Wollongong Local Planning Panel Assessment Report | 17 February 2021

WLPP No.	Addendum Report to WLPP Item 1 - 3 November 2020
DA No.	DA-2020/572
Proposal	Residential - multi dwelling housing - demolition of existing warehouse storage facility and construction of 12 x two storey dwellings.
Property	481-485 Princes Highway, WOONONA NSW 2517 Lot 1 DP 86796
Applicant	MMJ Wollongong
Responsible Team	Development Assessment and Certification – City Wide Planning Team (SG)

ADDENDUM REPORT

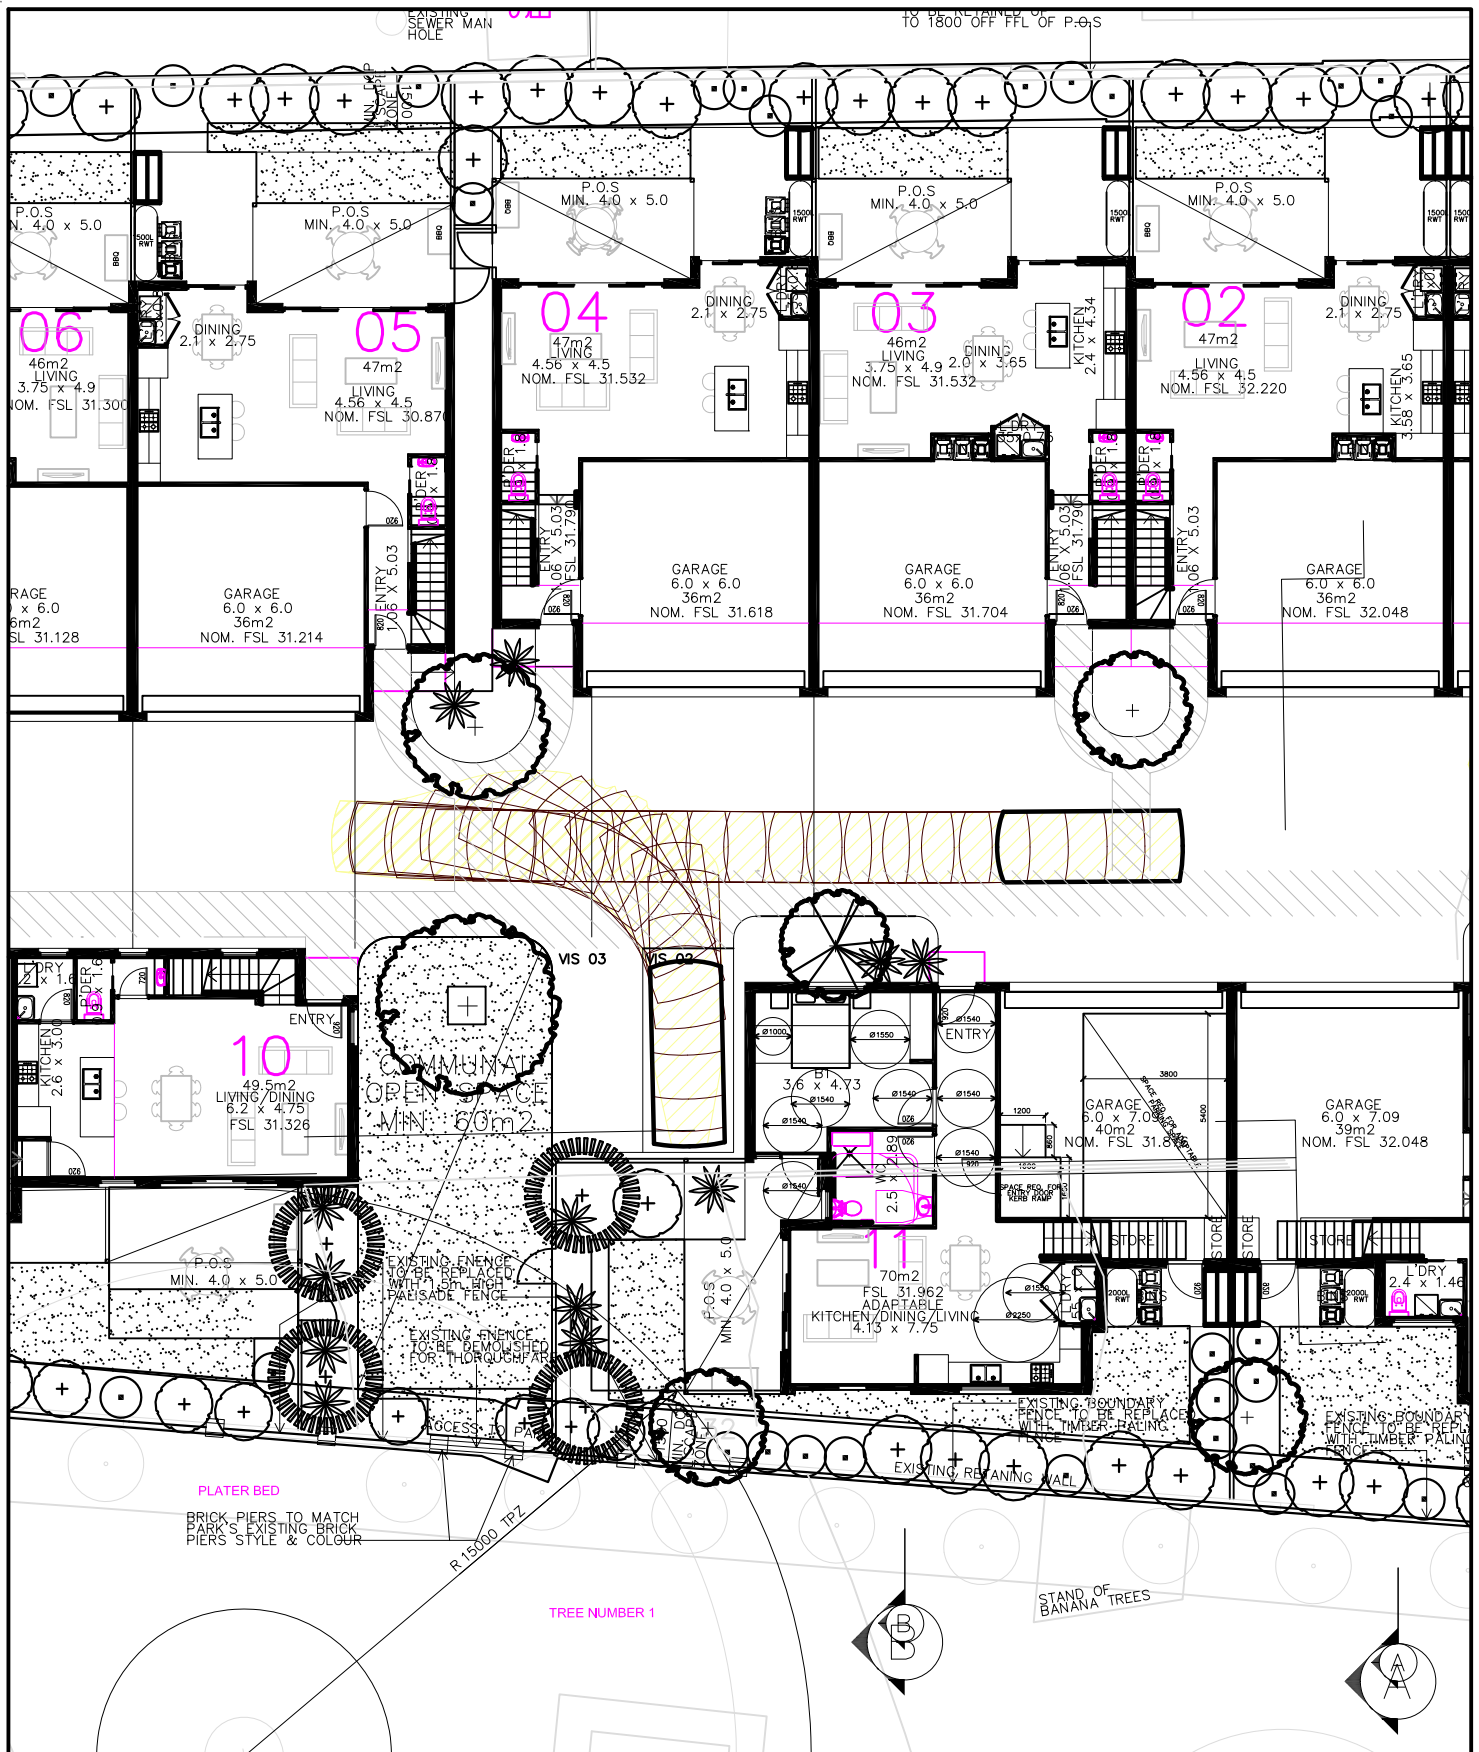
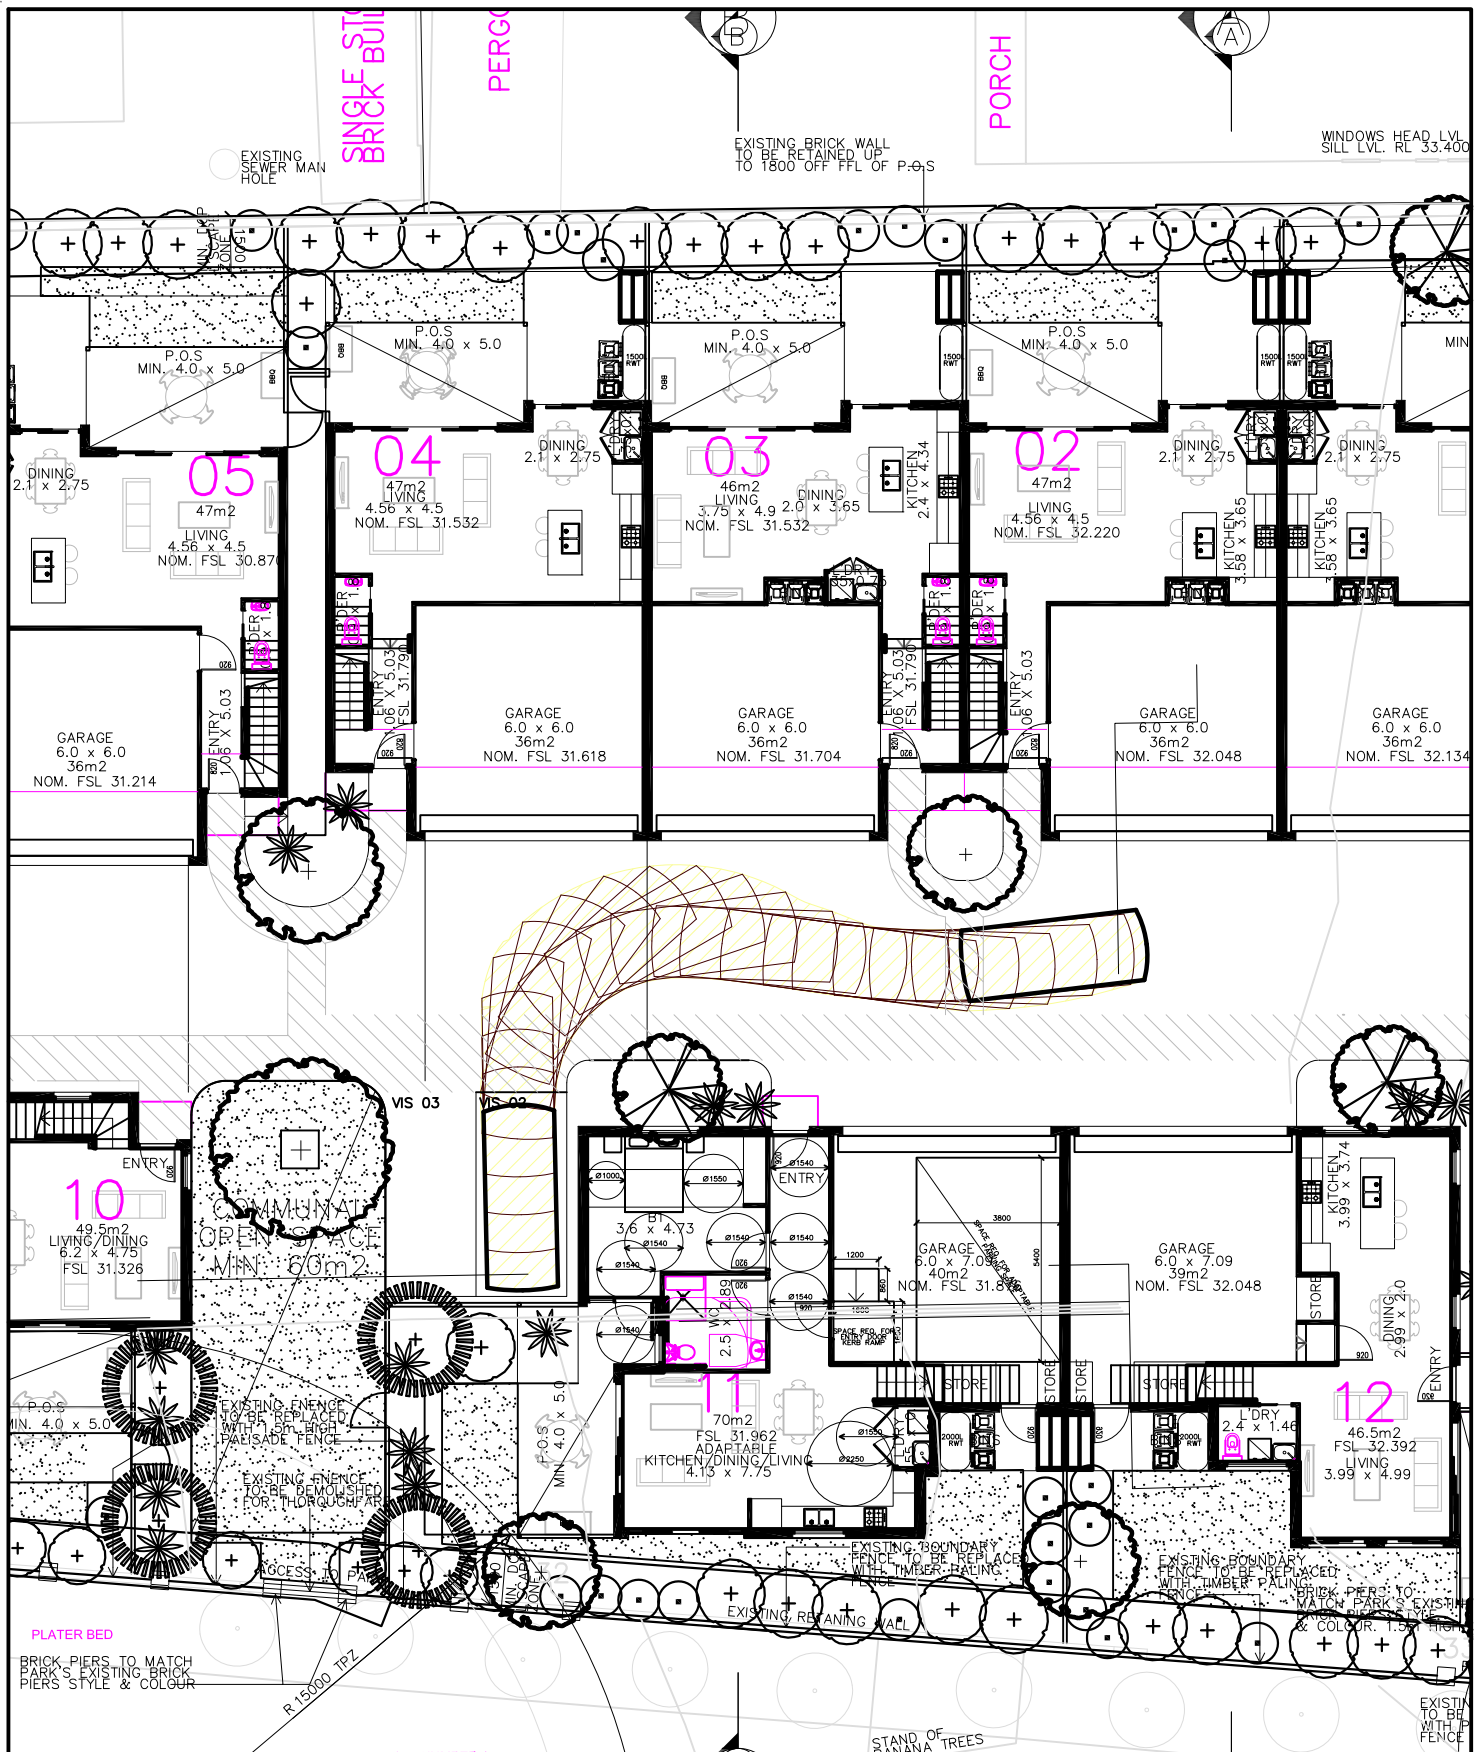
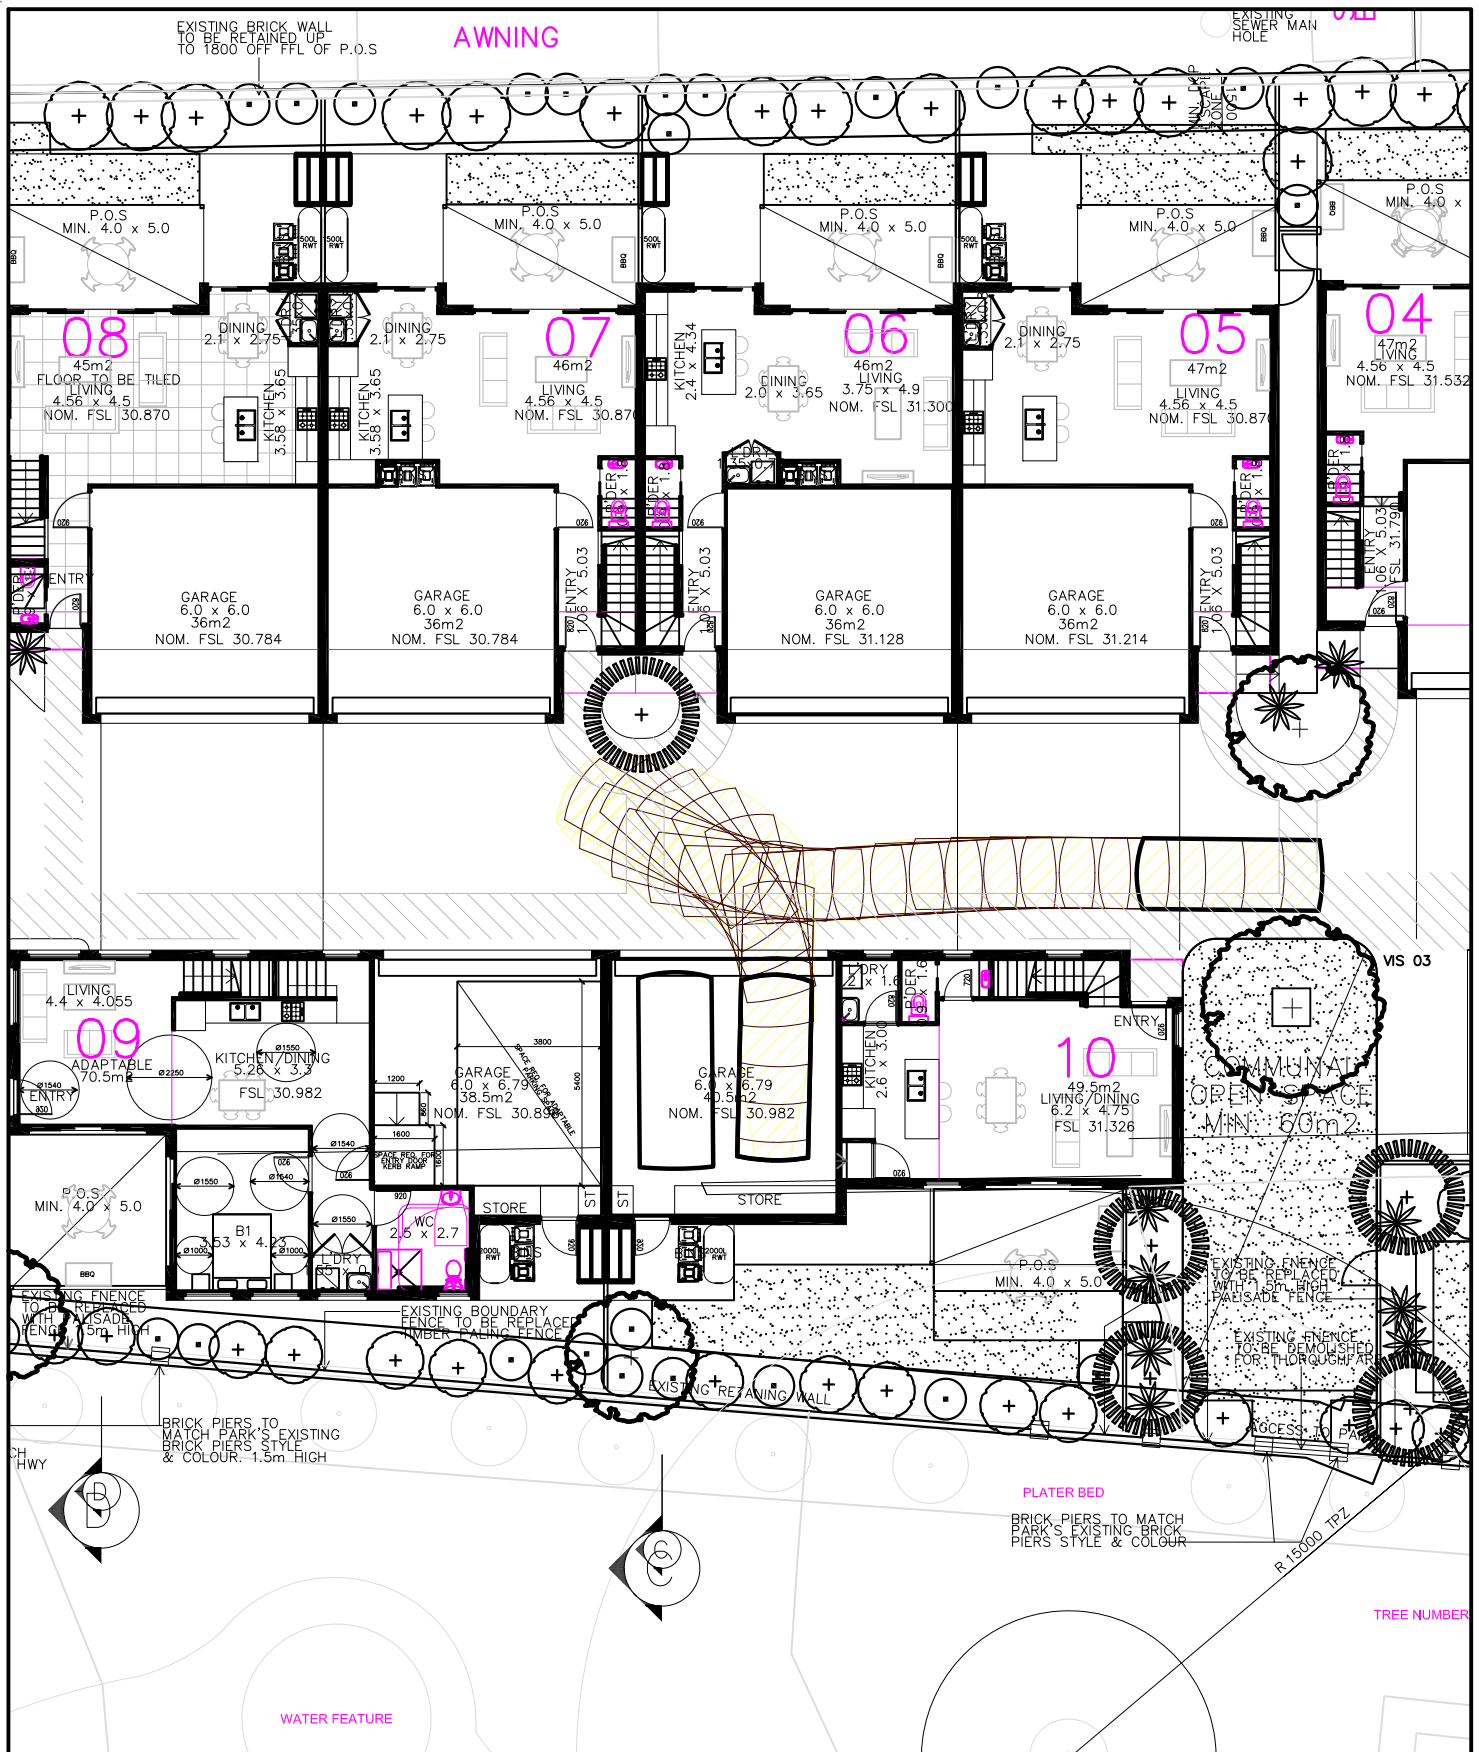
- *The visitors' spaces appear too narrow and are positioned in locations which prevent manoeuvring of vehicles in a forward gear. These need to be enlarged and relocated. It may result in a reduction in GFA. The Panel considers that locating visitors' spaces and turning facilities in direct proximity to dwellings front doors is undesirable from an amenity and safety perspective.*

It is confirmed that the visitor spaces are in fact the correct size to meet compliance with the Australian Standards. Please refer to AR 101 revD and AR151 revC where the spaces are now clearly dimensioned. Reference should also be made to the swept paths provided by TTPA traffic engineers demonstrating this compliance ingress and egress vehicle movements. Specifically the templates SP4,5,6, 7, 17 and 18.
